**SITE PLAN REVIEW TECHNICAL ADVISORY COMMITTEE
PORTSMOUTH, NEW HAMPSHIRE**

AGENDA

April 7, 2026

SITE PLAN FOR BRIDGE STREET INN

FIRST FLOOR PLAN

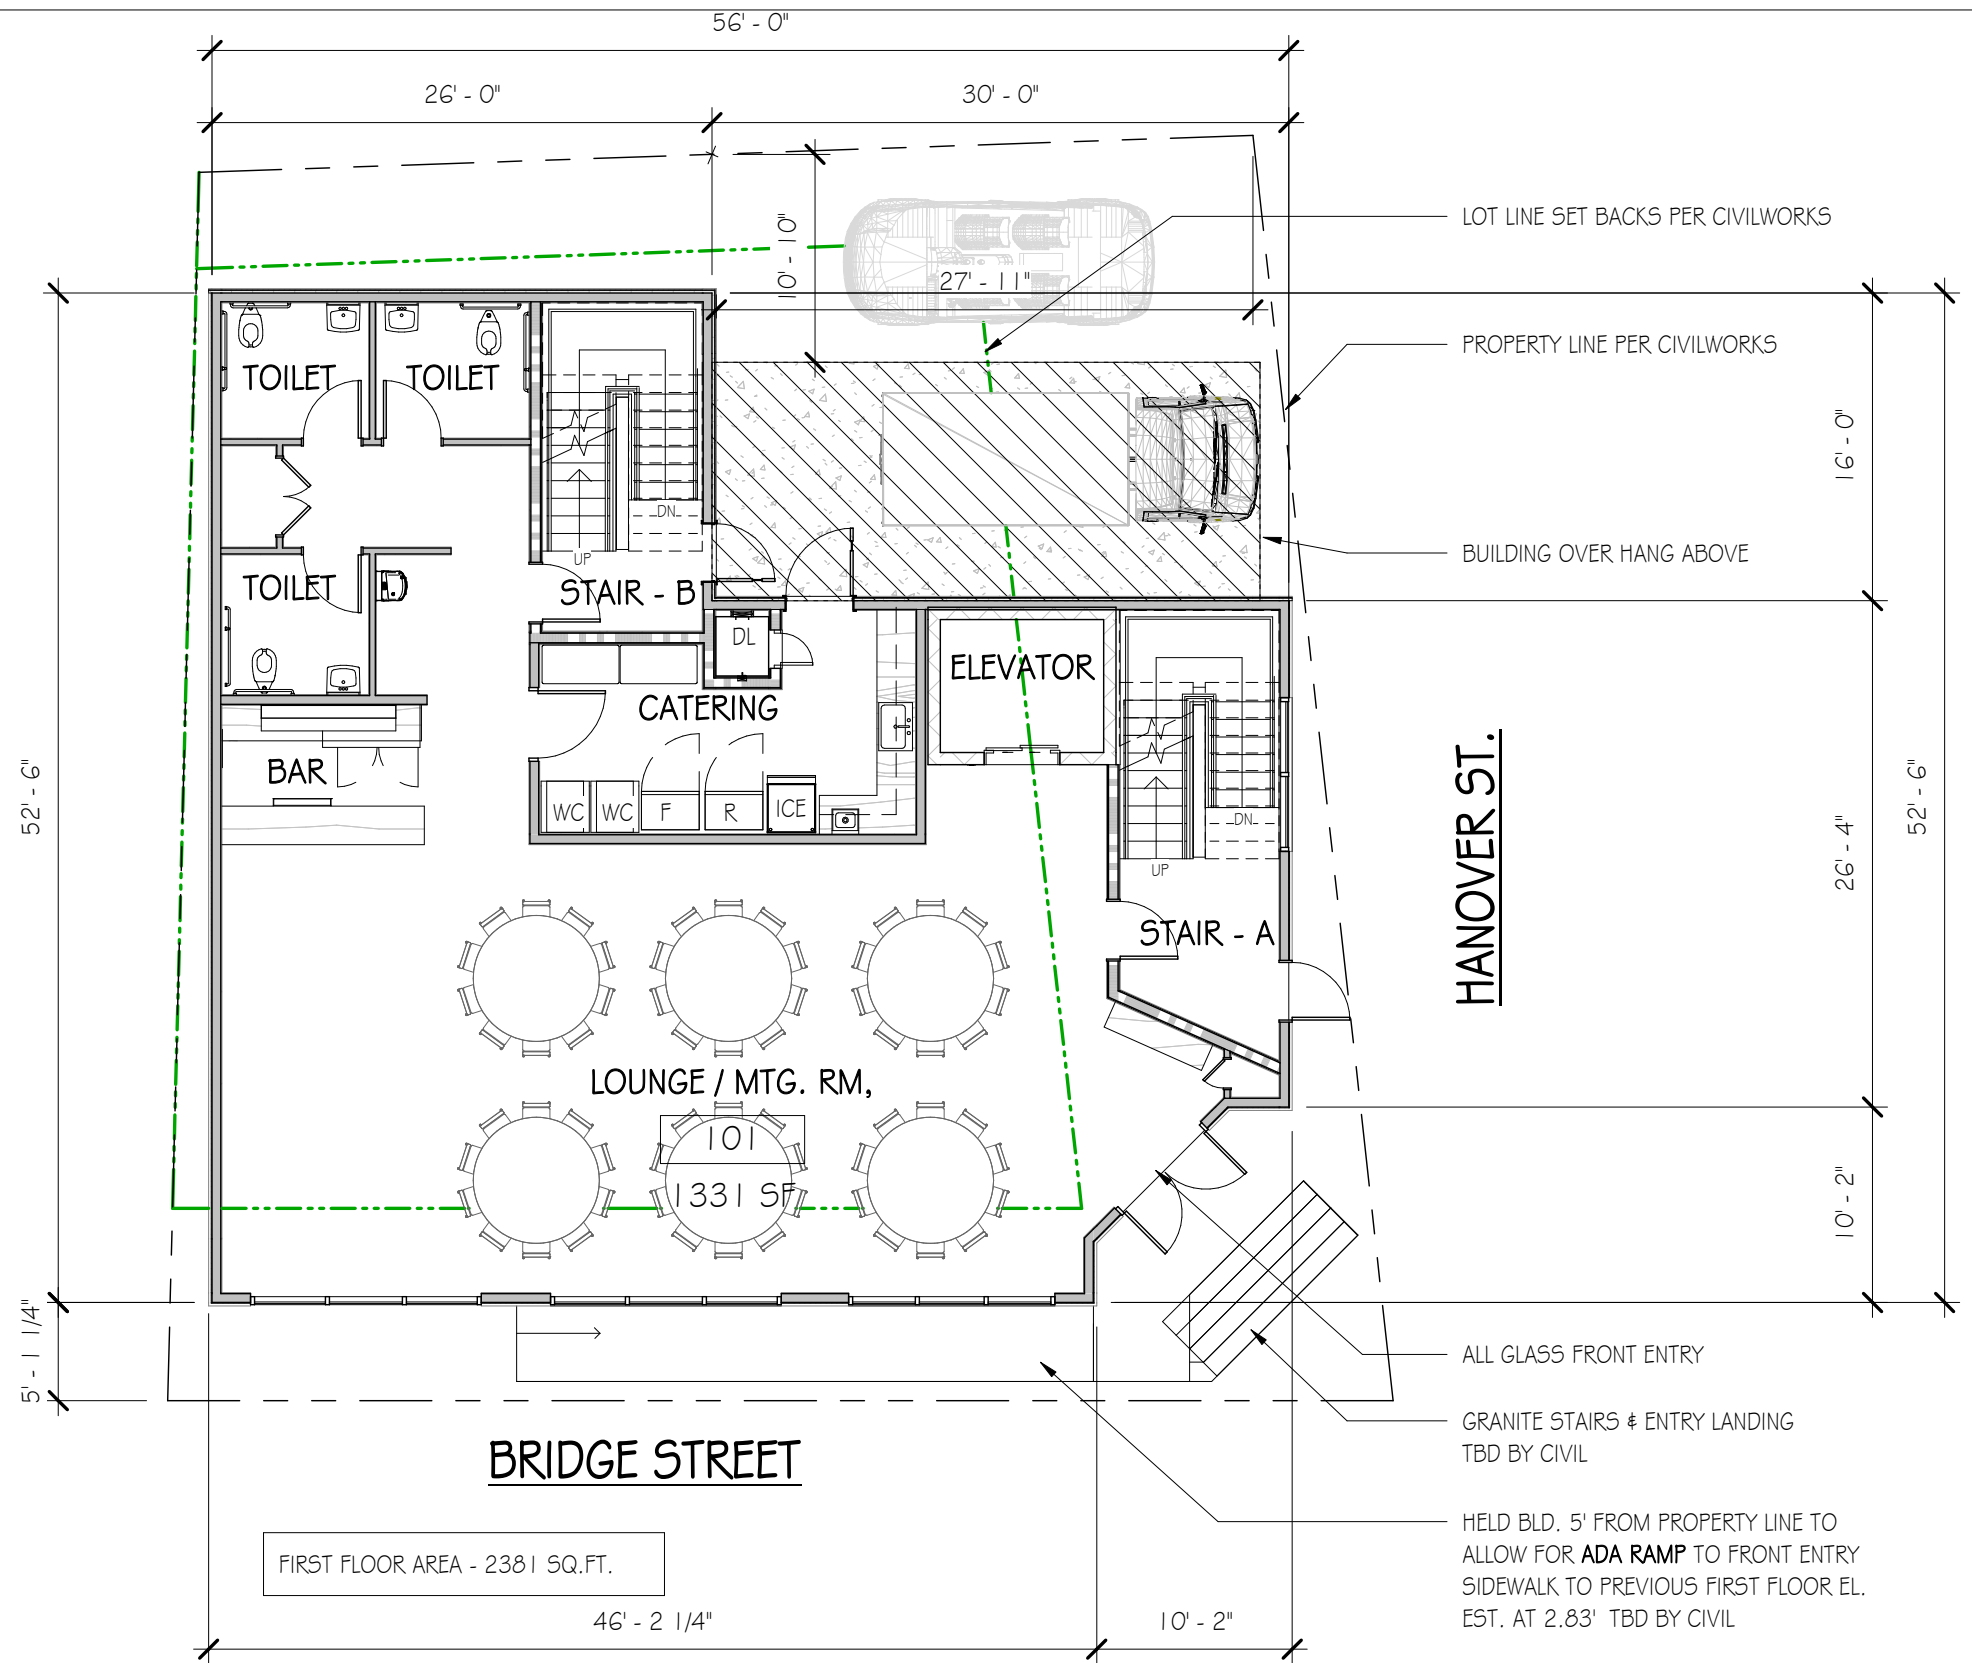
1. The stair no longer has an egress door to the outside.
 - A. We will need to added a small rated hall. (The dumb waiter is not allowed in the egress hall)
 - B. Or flip the stair landing and add a hall to the floors above shrinking a hotel room for said hall.
2. The third toilet room came from a request in the 9/30/25 virtual meeting. By Code two toilet rooms is adequate.
